## Rules Review of Lorencito RN5

**Re: Lorencito Canyon Mine; Permit C1996084  
DRMS Preliminary Adequacy Review of Permit Renewal Five (RN5)**

**Alluvial Valley Floors Map**

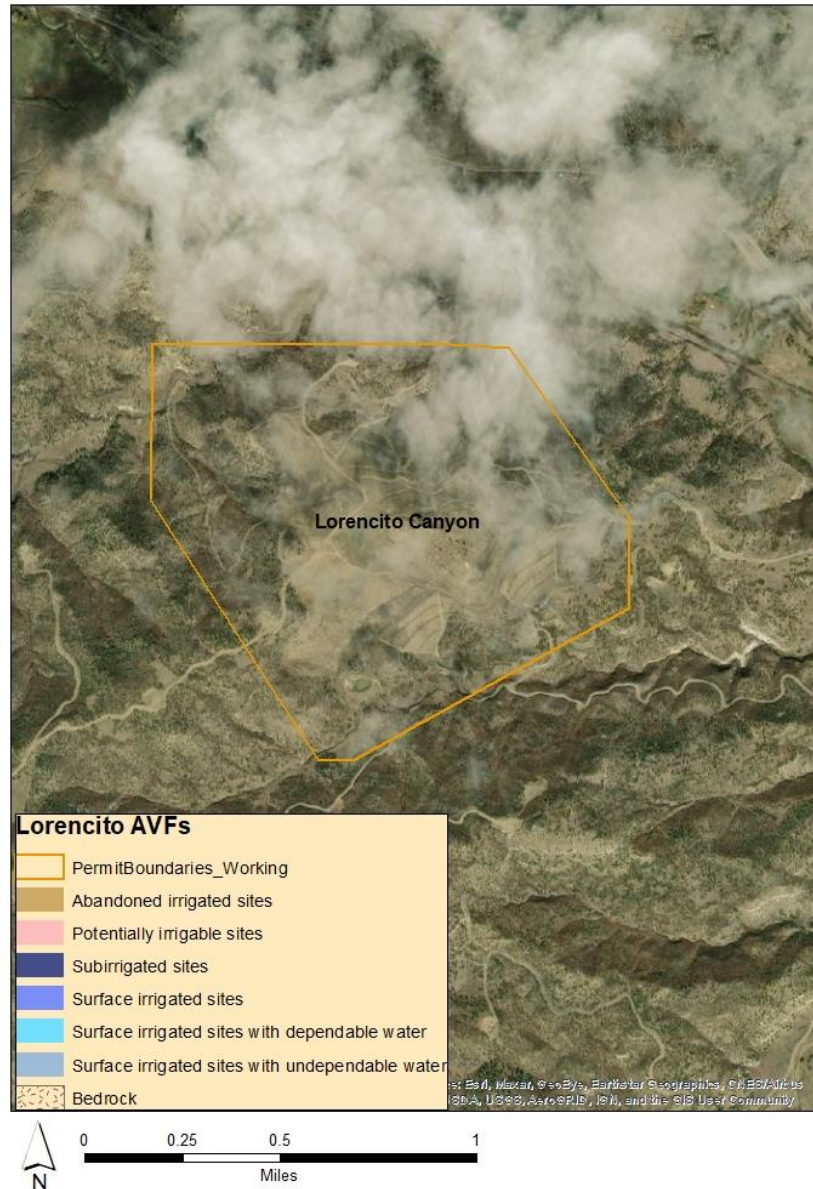
According to the OSM map of Potential Alluvial Valley Floors (AVF), no AVF's or potential irrigable areas exist within the Lorencito Mine permit boundary or the surrounding area as per the map excerpt below.
